MONTEREY BAY AQUARIUM RESEARCH INSTITUTE 7700 SANDHOLDT ROAD MOSS LANDING, CA 95039 (831) 775-1700 www.mbari.org Copyright MBARI 2000		
Engineer Alana Sherman	Layout Jose Rosal	
Date Tuesday, December 05, 2006	File Name Gulper: Node Controller	Rev 0.1.3

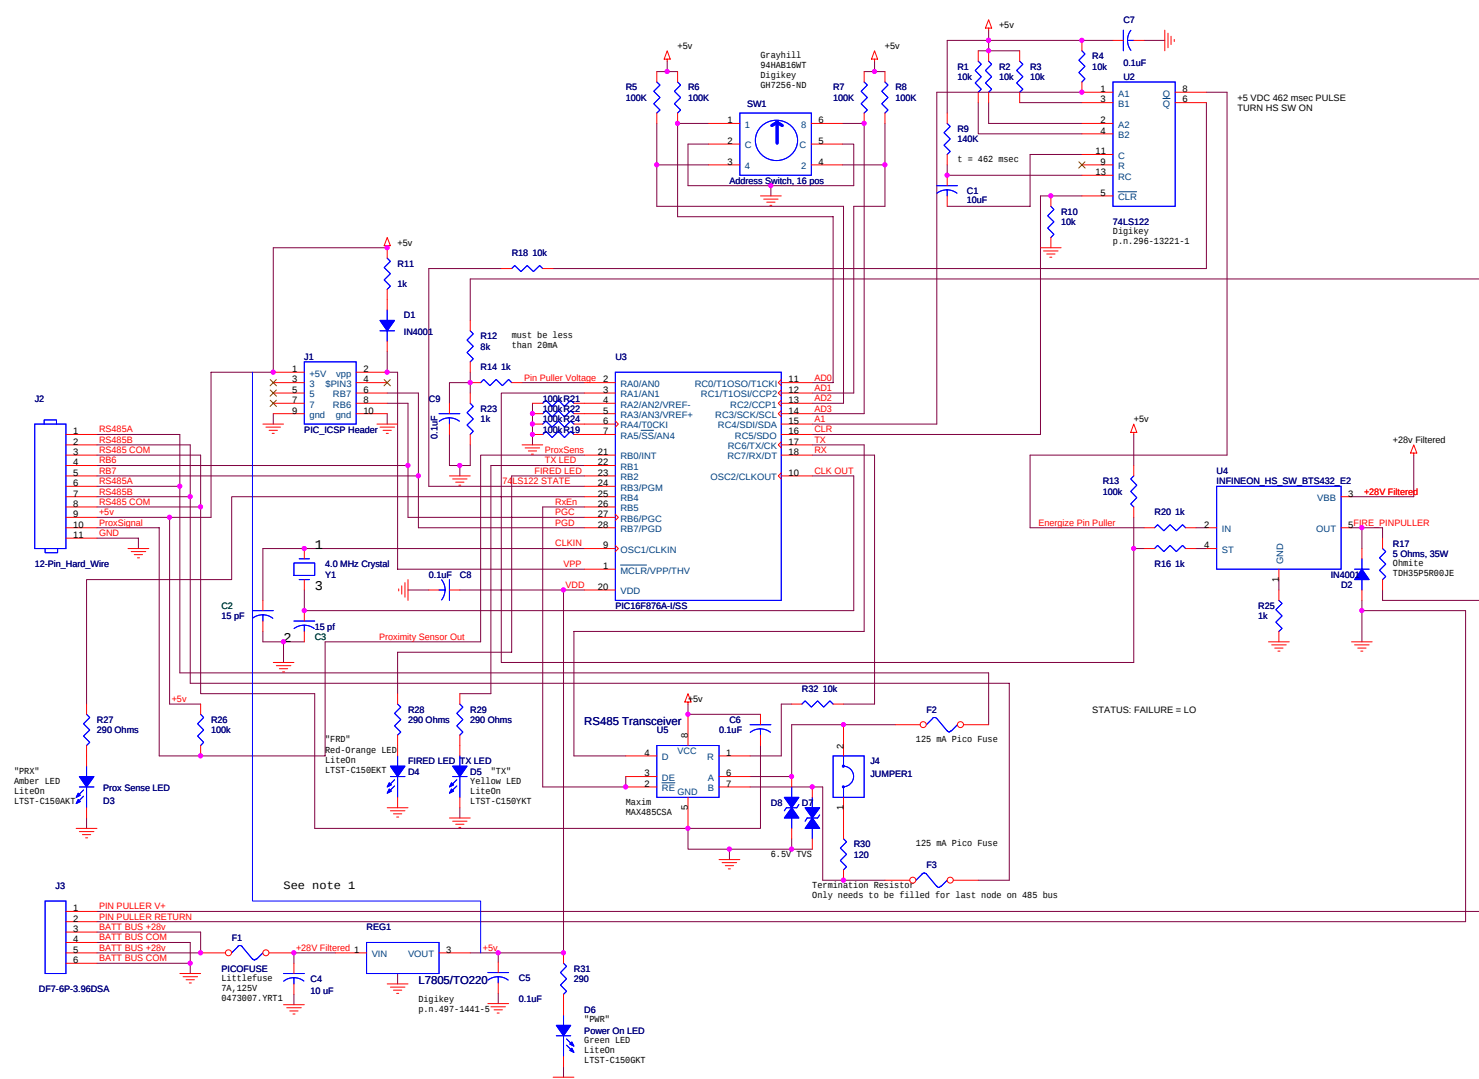
- Notes:
1. External wire is needed to connect pin3 of reg1 (L7805) with pin 1 of J1 .
 2. Pin 9 of U2 needs to be lifted off the pad to prevent it's connection with +5v.

Revisions			
JRosal 090806	Added C6, C7, C8, R18		
	CONNECTED U3-25 TO "PRX" LED		
	SHORTED U5-3 AND U5-2 TOGETHER.		
ASherman 092606	Added F2 and F3		
ASherman 101806	Added net name to pin 3 of L7805		
	Pin 9 of U2 should be a no-connect
